1997 - 1998, 2000 Corvette: Service Bulletin: Electronic Steering Column Lock May Refuse to Operate - DIC Service Message Displayed

Source: Chevrolet Dealer Service Bulletin

Number: 01-02-35-008

Subject: Electronic Steering Column Lock May Refuse to Operate - DIC Service Message Displayed (Update Column Lock Wiring, Install Revised Relay and/or Replace Electronic Column Lock)

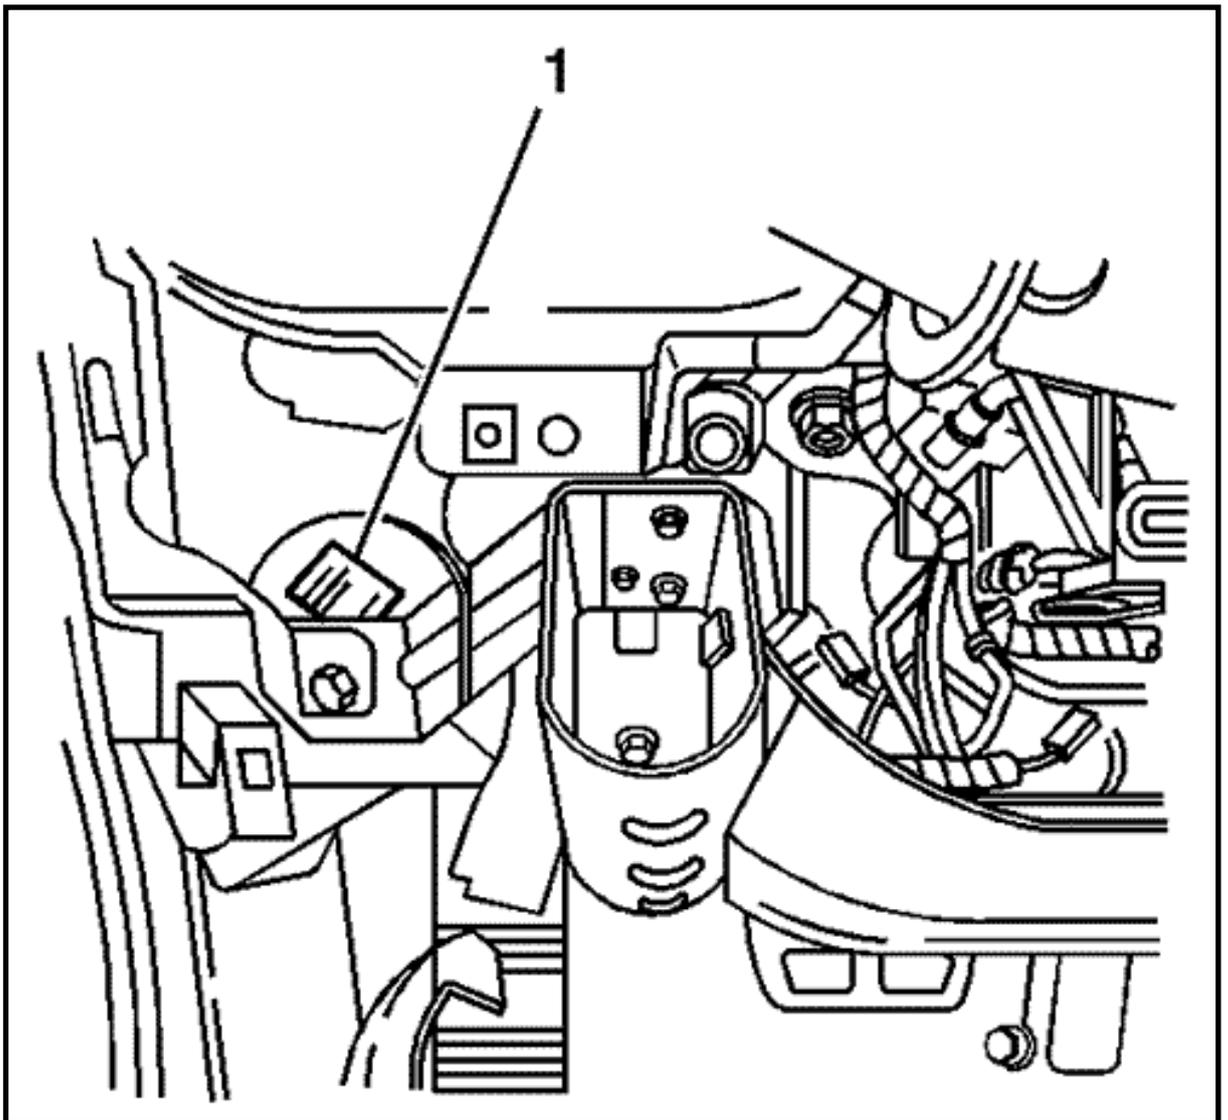
12. Remove and discard the Steering Column Lock/Cam Orientation plate

using the J 38364.

13. Install the included Cam Orientation Plate and secure with a new locking ring, using J 42137 and J 38364 as shown.
14. Install the SIR coil and secure with snap ring.
15. Disconnect the connector from the ECL (located on the right lower side of the steering column) to the I/P main harness.

FIGURE 1997 and 1998 (early) Automatic (U.S. & Canada)(c)

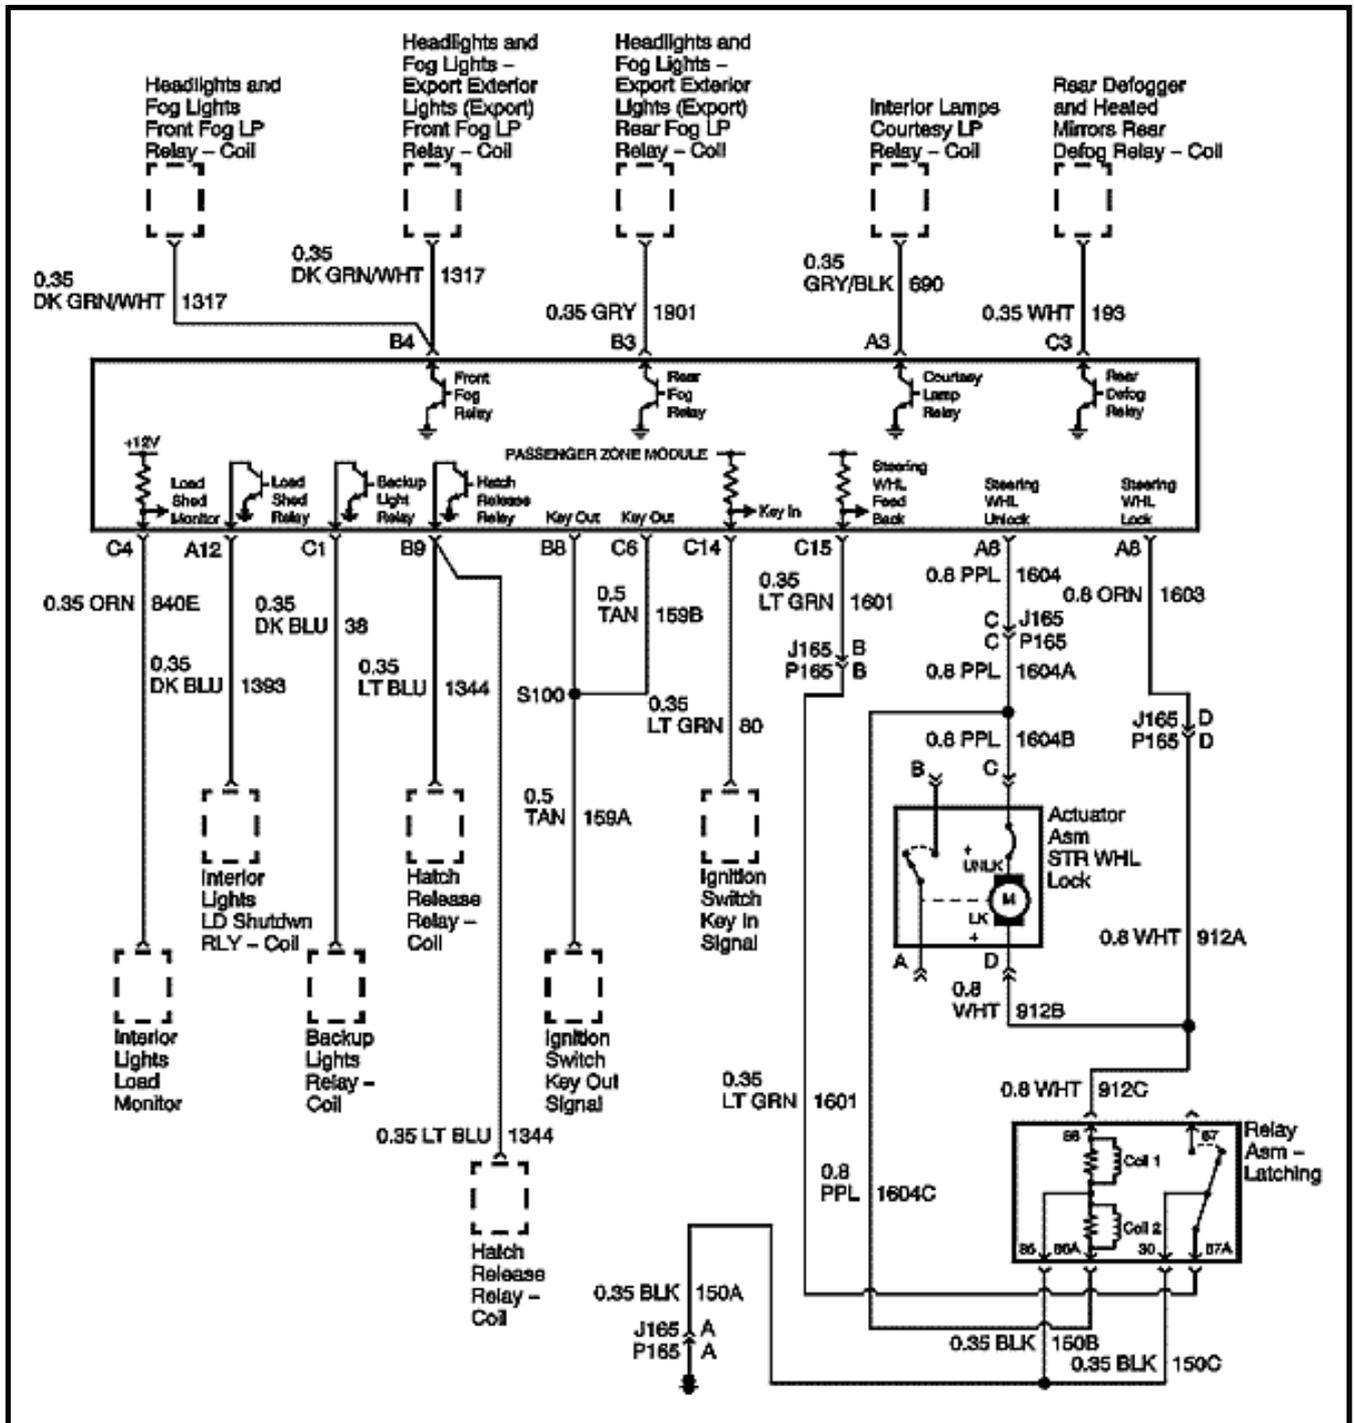
16. Route the new jumper wire and relay harness over the knee bolster (styrofoam and metal construction). The new relay (1) must be mounted to the left I/P brace with a zip tie as shown.

17. Install the new relay and jumper harness. Plug one end of the jumper harness into the connector on the I/P harness side. Plug the other end into the connector on the ECL side. The connectors on the jumper are specific and cannot be connected incorrectly. The connector becomes J165/P165.
18. Install the lower and upper steering column shrouds.
19. Install the wiper control stalk.
20. Install the tilt steering lever.
21. Install the steering wheel to the steering column.
22. Install a new steering wheel set nut, P/N 26056108. **Tighten**

FIGURE 2000 (late) Manual and All Export (c)

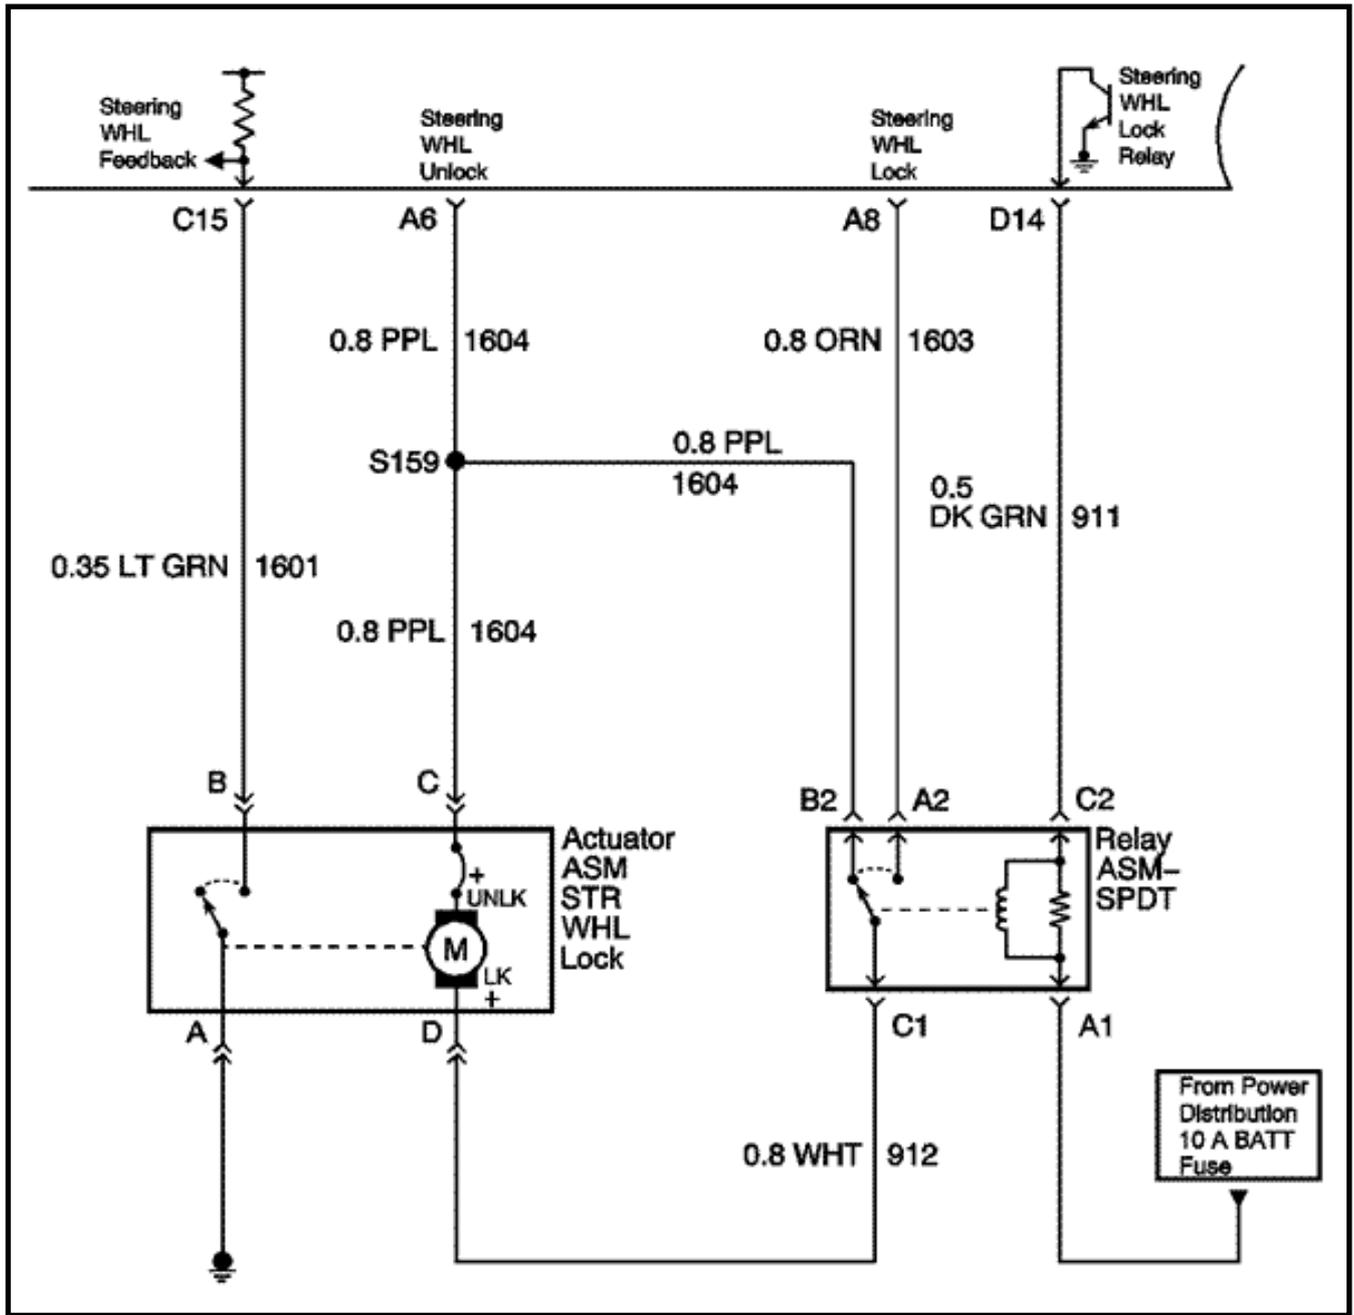
9. Remove the ECL relay harness from the backside of the relay assembly.
10. Remove the relay.
11. Remove the orange wire from position C1 on the ECL relay connector.

12. Remove the white wire from position A2 on the ECL relay connector.
13. Swap the two terminal positions and re-insert, orange wire to A2 and white wire to C1.

14. Add the new purple wire from the jumper to terminal position B2.
15. Install the new single pole, double throw relay.
16. Install the Green 16-way connector to the BCM.
